工程指示 / 要求簡箋(E.I.)

工程指示編號：EI / 2449 / 20

工程名稱：亞皆老街中電

工程項目：佛沙窗 主人房廁所窗加欄河玻璃

**ELEVATION OF
T3B (SHOULD
BE HANDED)**

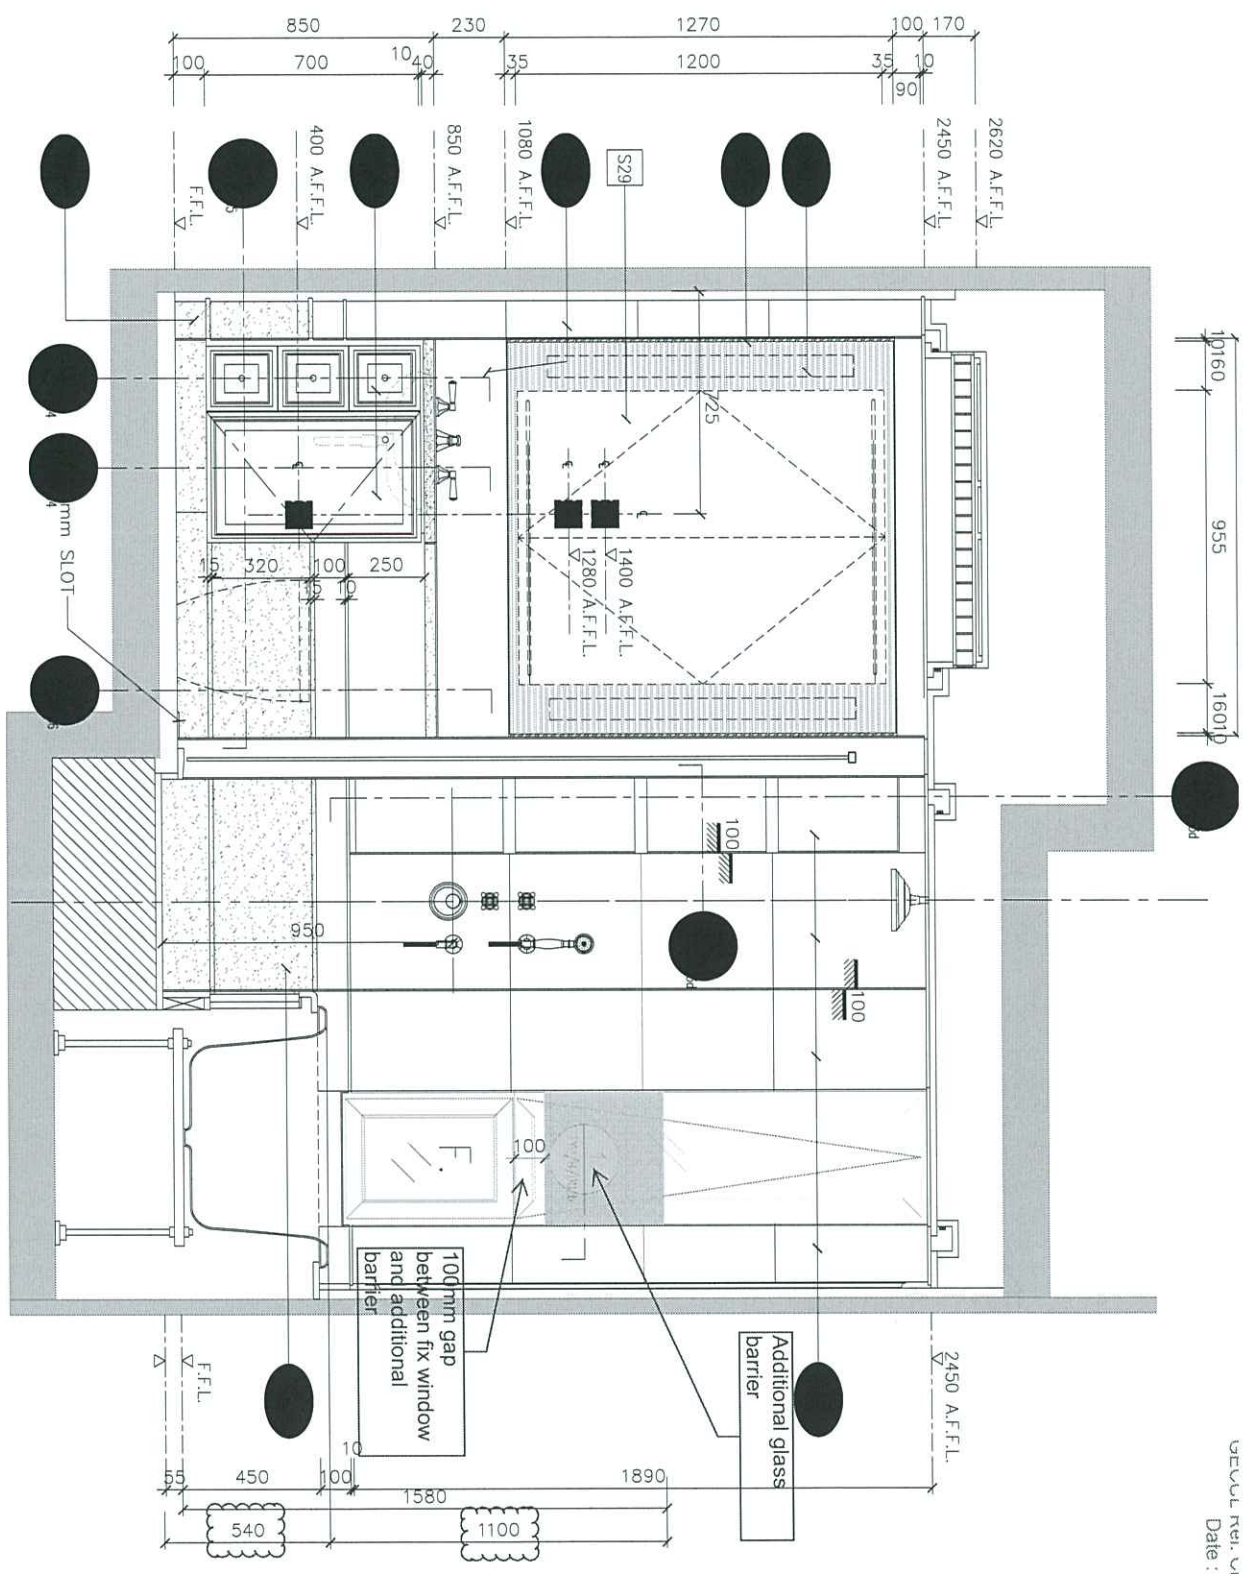
Further to our discussion just now, please advise if it is technically feasible to add an additional glass barrier as per attached sketch as per Pacific Shine (Sino)'s request during timber mock up visit this morning.

The additional glass barrier shall be applied to T1B, T2A, T2B and T3B on typical floors.

It is feasible to add glass barrier for master bathroom at T1B, T2A, T2B and T3B. Please issue A.I. to cover the additional works for confirmation. Moreover, as precast windows for master bathroom at T2A, T2B and T3B (1/F to 3/F) were delivered to facade factory, please note that these windows would be rectified at site.

1/F Plan

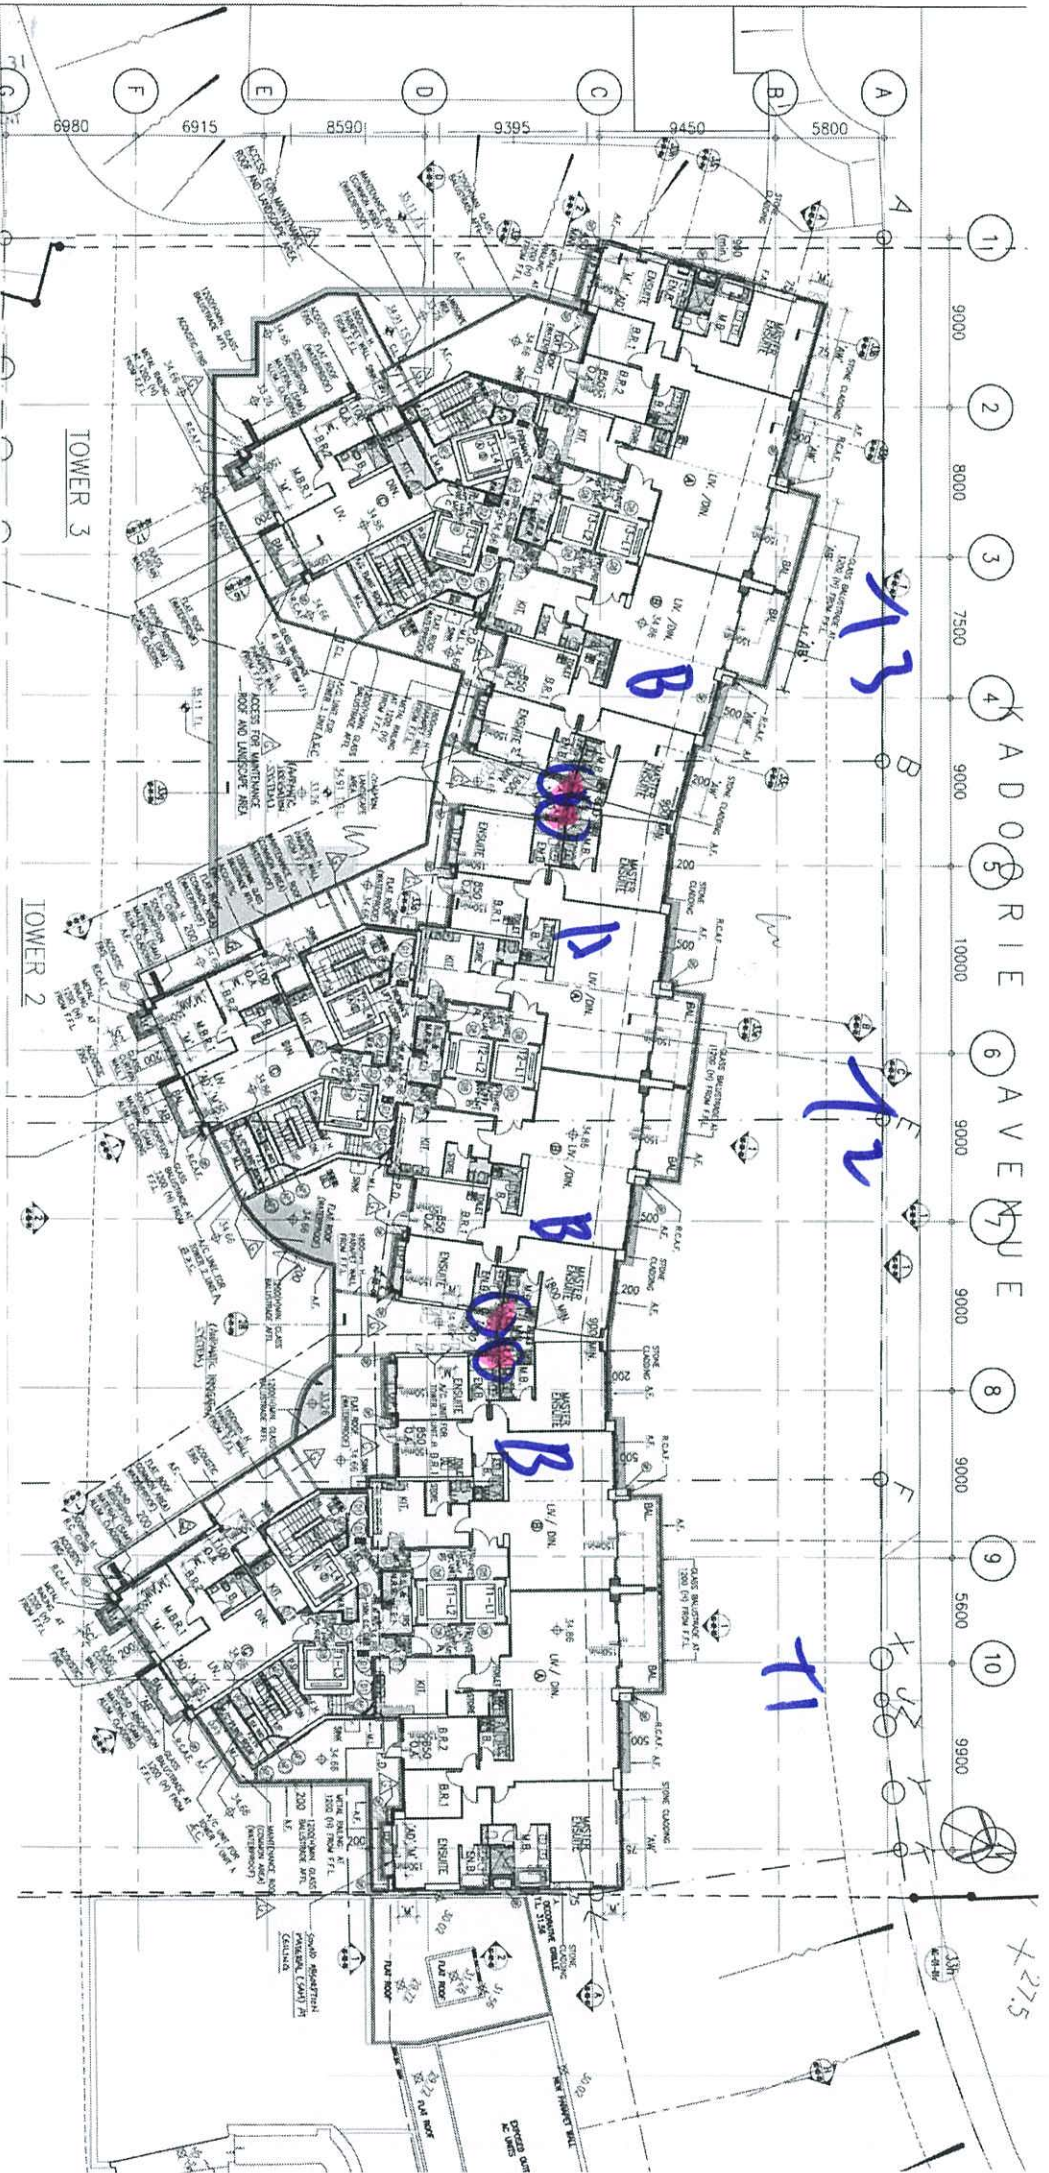
Additional glass barrier to aluminium windows

22/F Plan

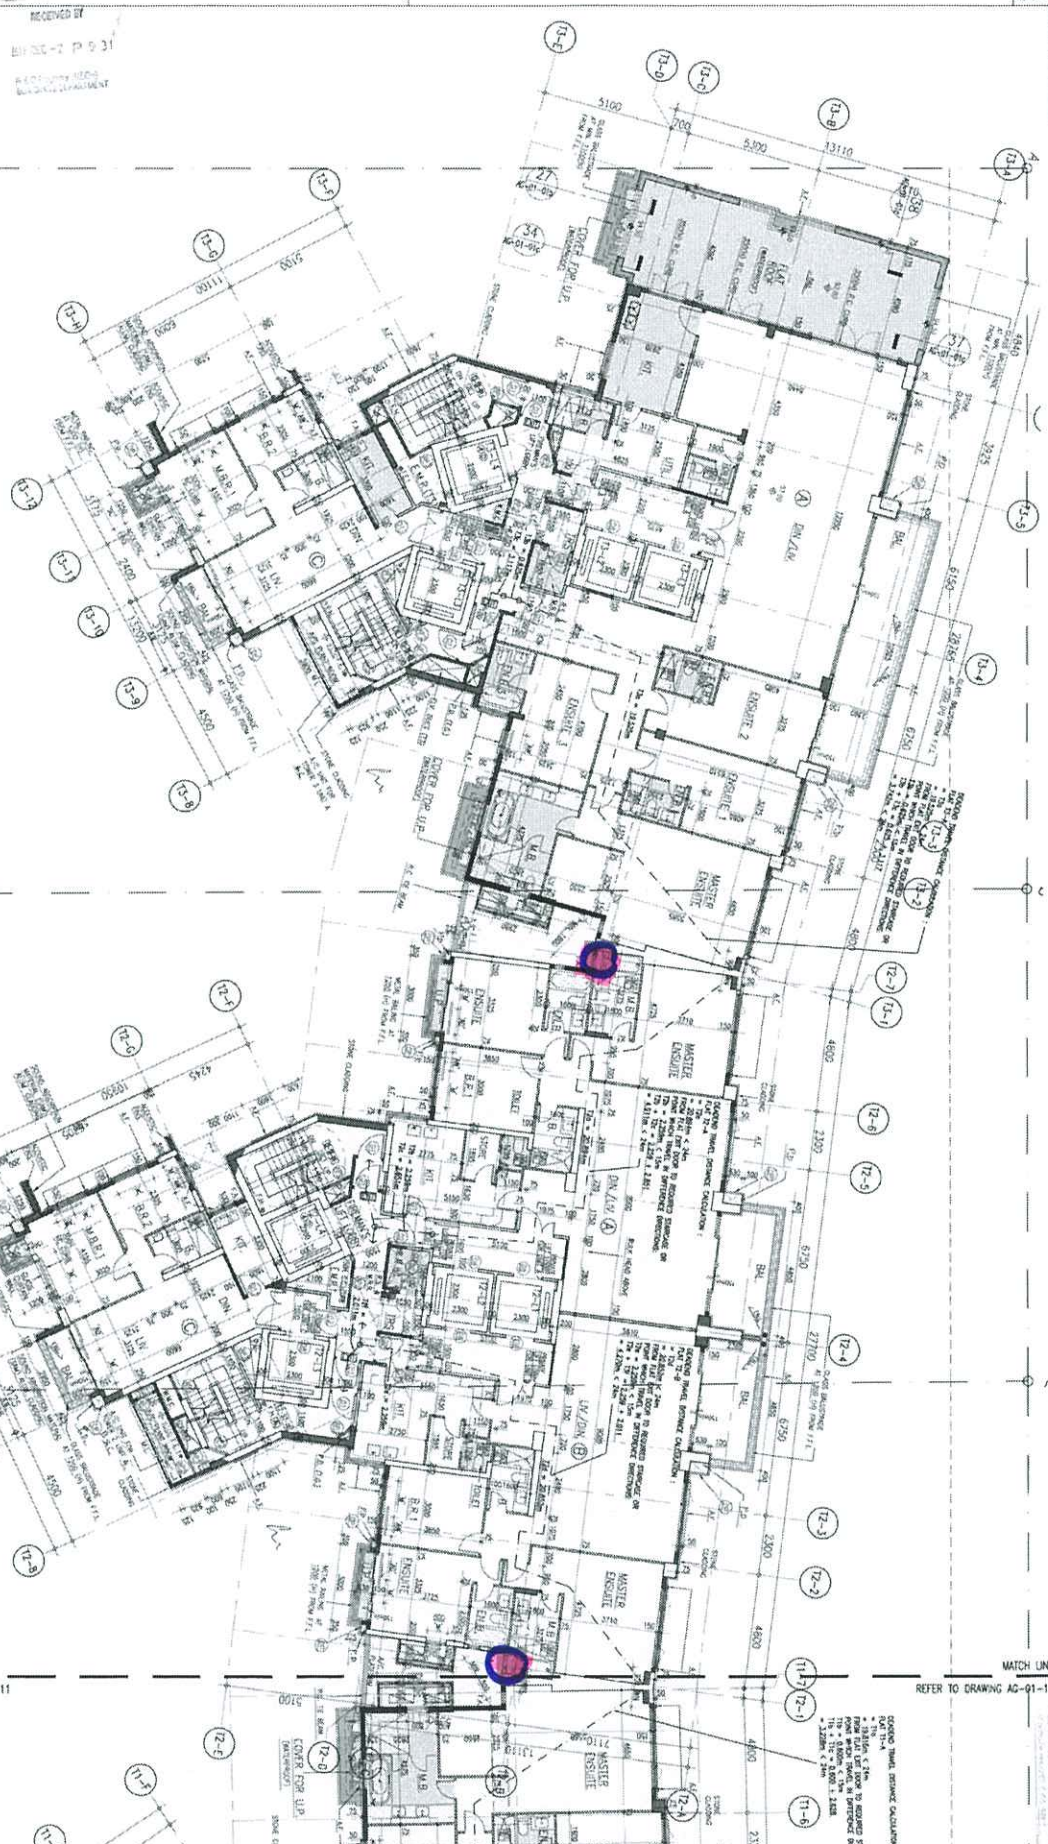
Additional glass barrier to aluminium windows

23/F Plan

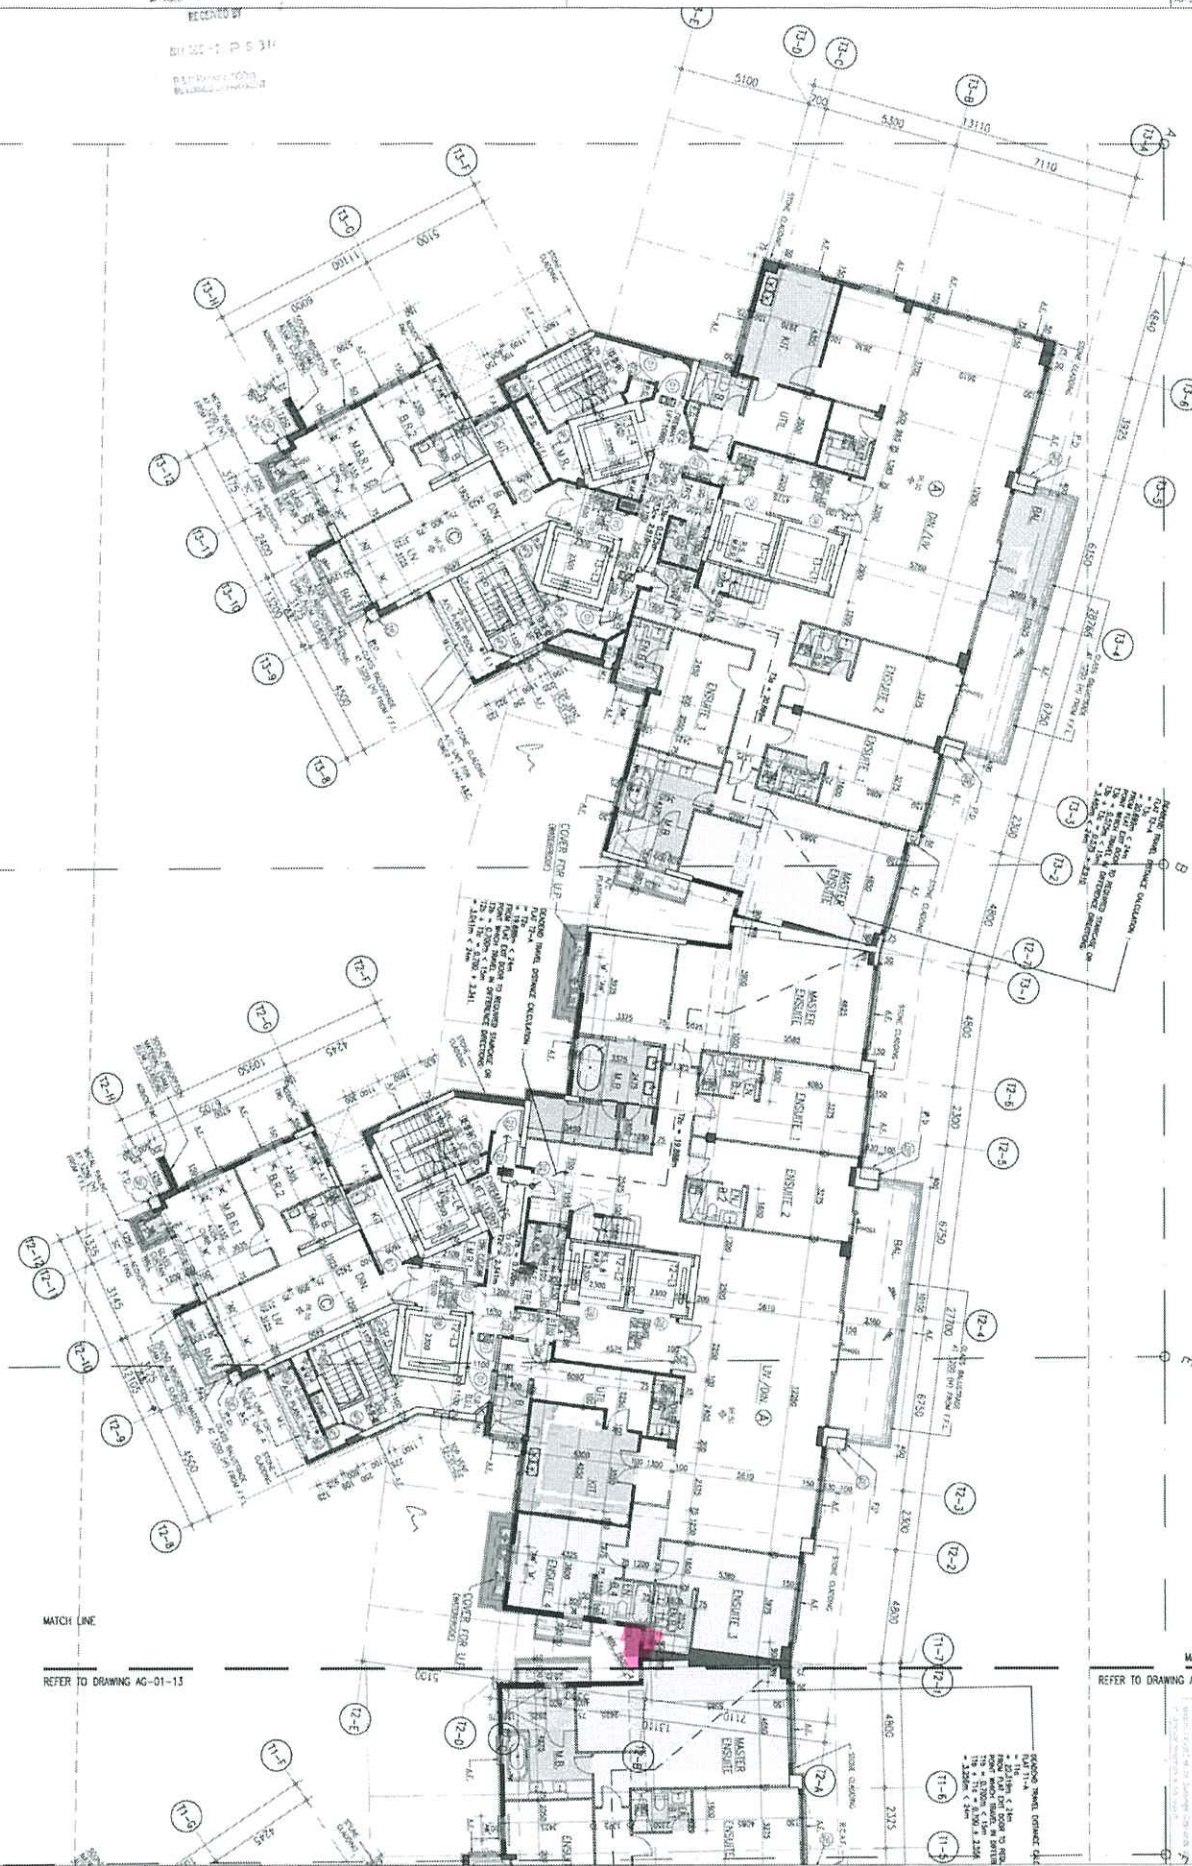
Additional glass barrier to aluminium windows
